Hollybrook

SEPTIC FIELD LAYOUT
LOT # 14

Hollybrook Subdivision Septic Specifications
Iredell County , NC

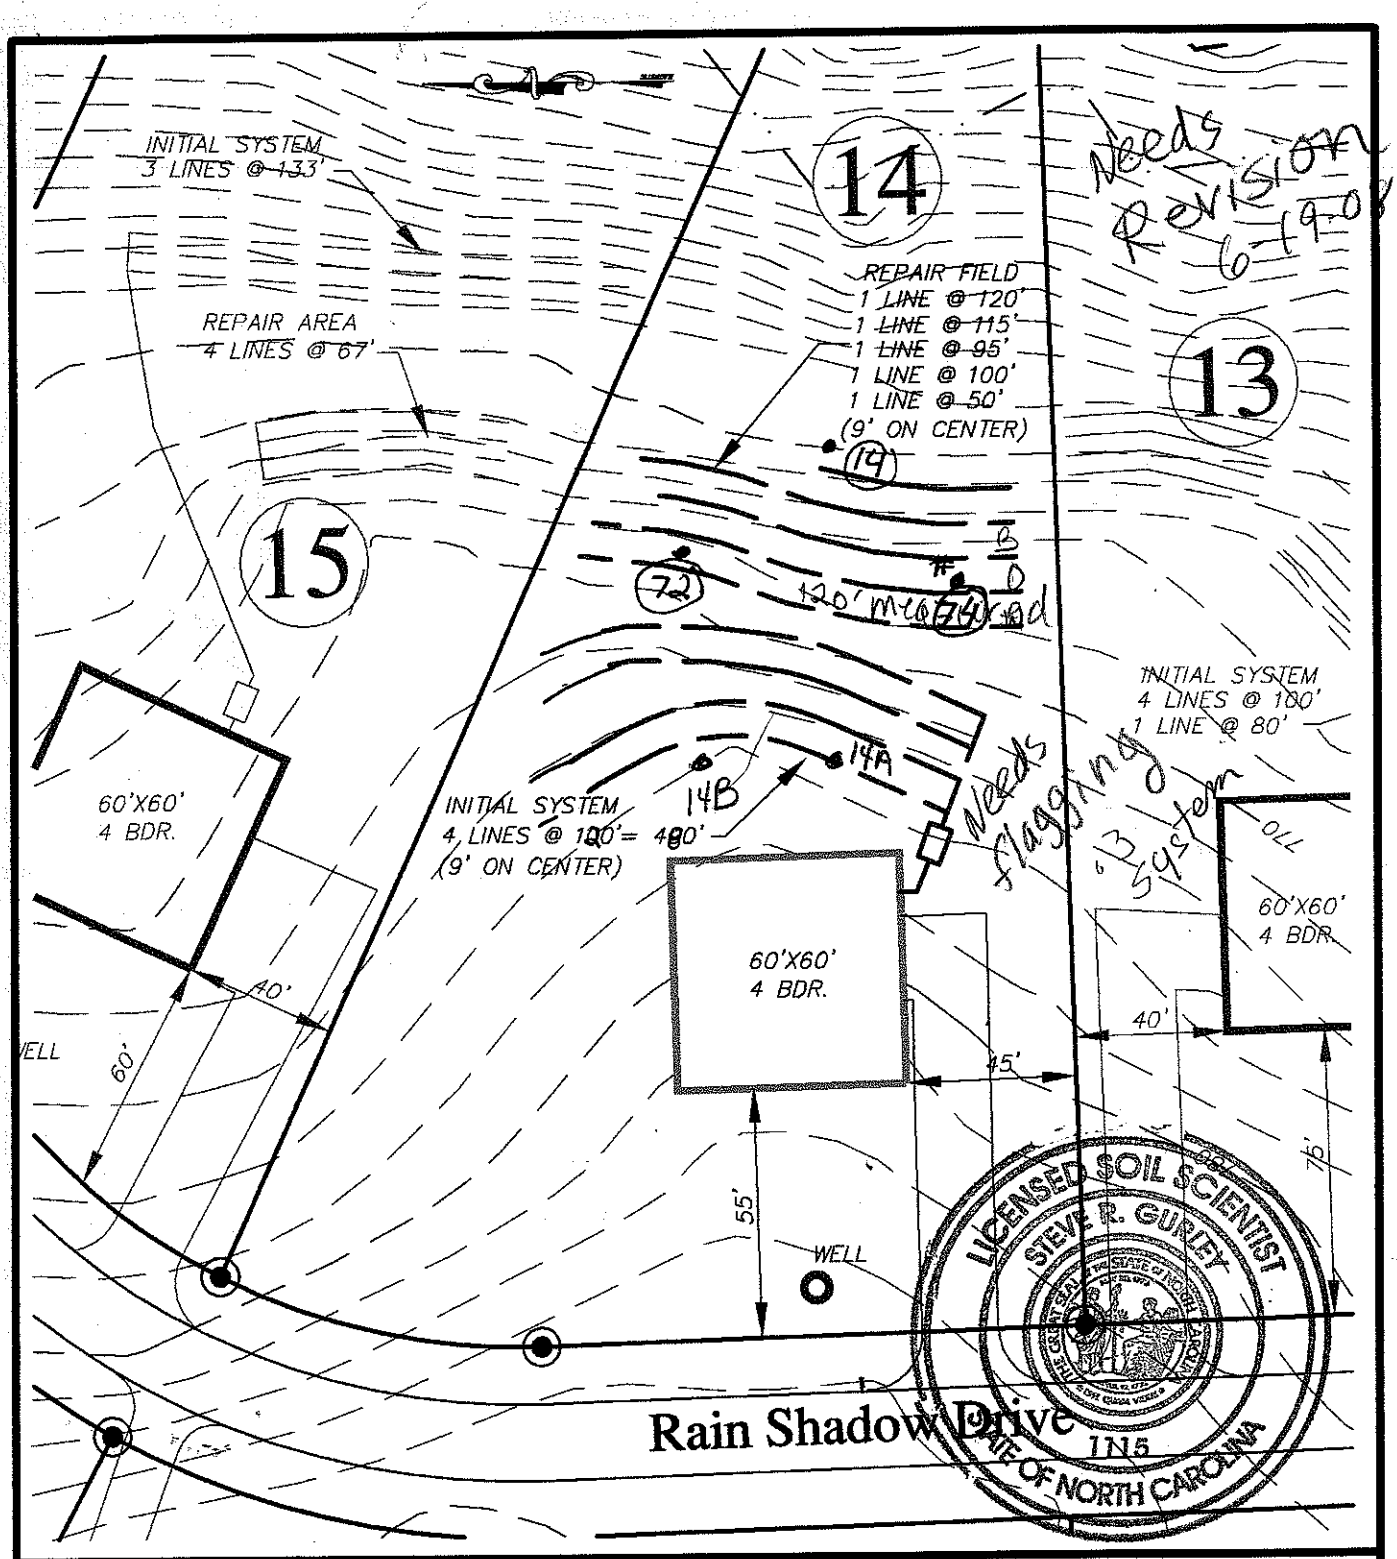
4-BR Initial LTAR-0.13 @ 25% Red = 400 lin. ft. = (4) 3'x100' Serial Dist
480gpd Repair. LTAR. 0.25 @ 50% Red = ~~355~~ 320' lin. ft. (4) lines - 2-100', (1) 110', (1)-55' LPP Dist. center feed.
